INSTRUCTIONS FOR INSTALLING THE 160387 OR 160388
MODIFICATION KIT ON A MODEL 28 CABINET (LAAC)
TO PROVIDE A RELAY RACK BRACKET

Addendum to Specification 5915S
Issue 5, Dated July, 1962

ADDENDUM TO SPECIFICATION 5915S, ISSUE 5,
DATED JULY, 1962 COVERING KITS 160387
AND 160388

FIGURE 1. 160387 MODIFICATION KIT TO PROVIDE RELAY RACK BRACKETS WITH 1-1/4" SPACING BETWEEN ROUND MOUNTING HOLES.

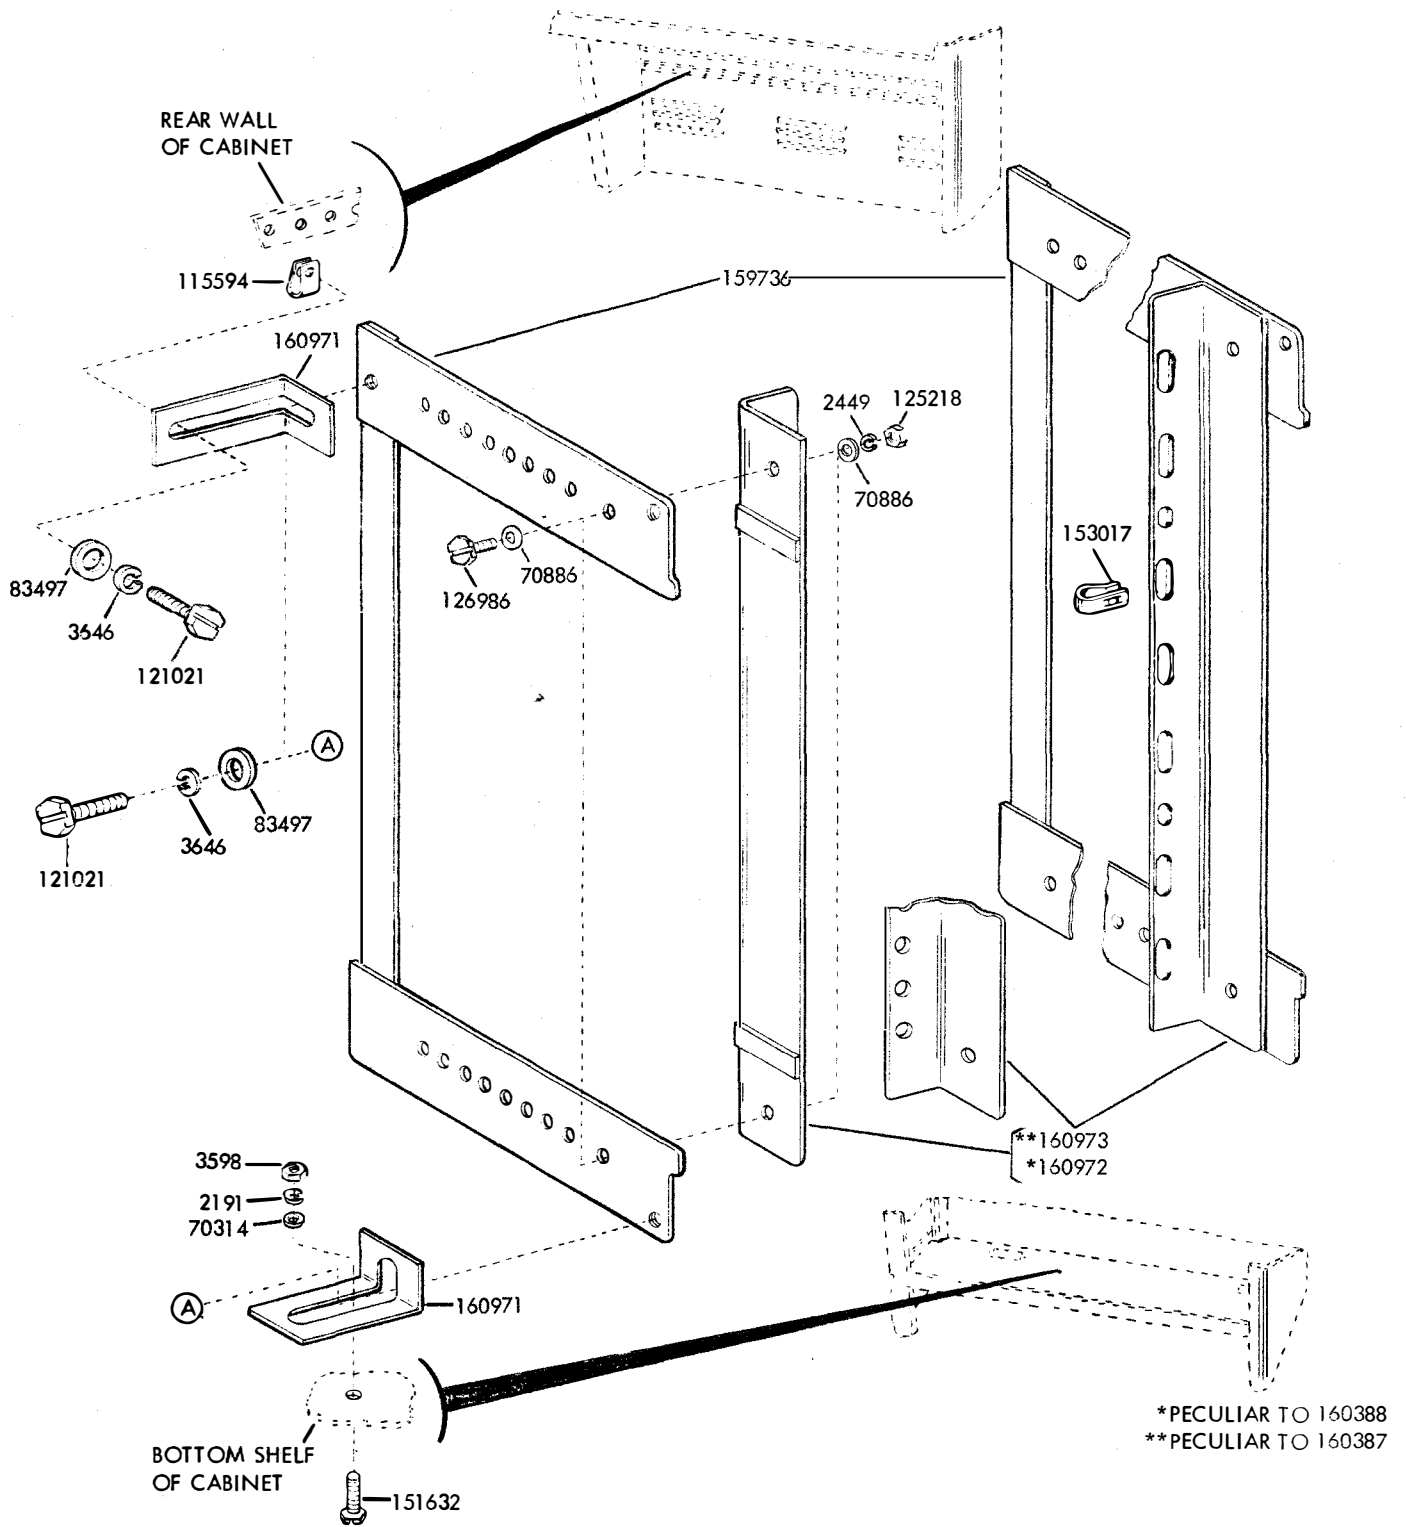
1. Make the following changes:
 - a. On page 1, para. 1.b. change the 121021 Screw to the 124612 Screw.
 - b. On Figure 1, change 121021 Screw to 124612 Screw.
